Product Change Notification

Change Notification #: 113396 - 00
Change Title: Intel® Server System R2308GZ4GC
PCN 113396-00
Product Design
Update the System Rear Panel and
BIOS/ME/BMC/FRUSDR Firmware
Date of Publication: November 07, 2014

Figure One

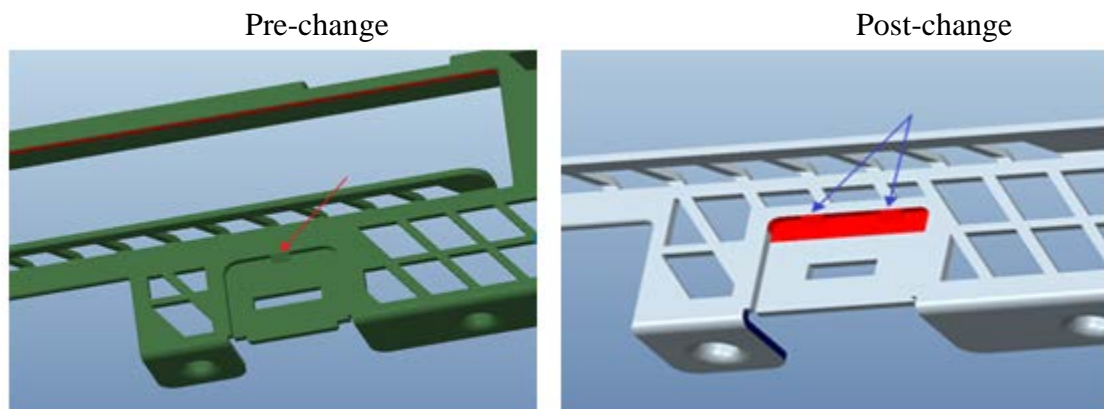
1. Update the one big center joint to two smaller joints so that the joints will not conflict with the LAN cable connector latch. See the Figure One.

Figure Two

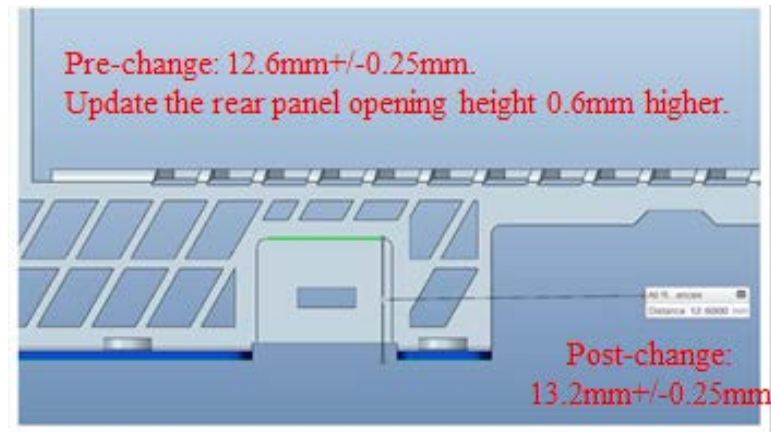
2. Update the rear panel opening height 0.6mm higher to improve the flexibility for the cable latch. The previous height was 12.6mm \pm 0.25mm. The updated height is 13.2mm \pm 0.25mm. See the Figure Two.

Figure Three

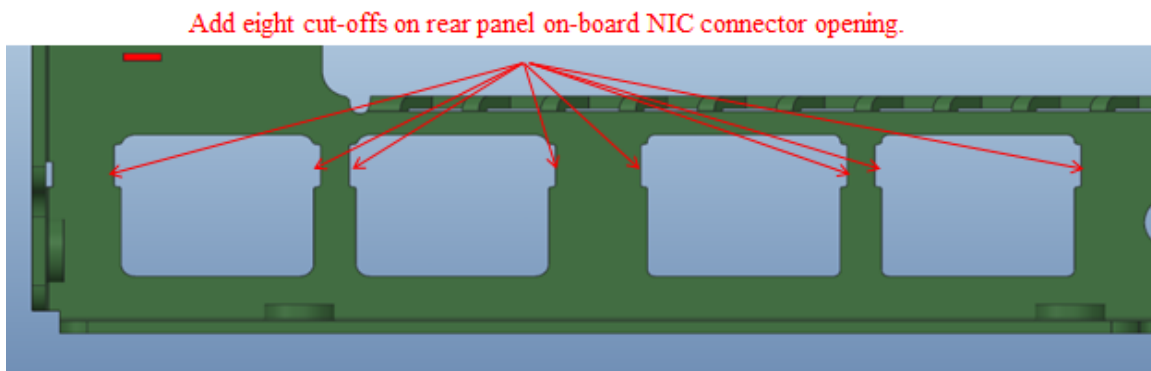
3. Add eight cut-offs around the on-board NIC (Network Interface Controller) openings to improve the LED visibility. See the Figure Three.
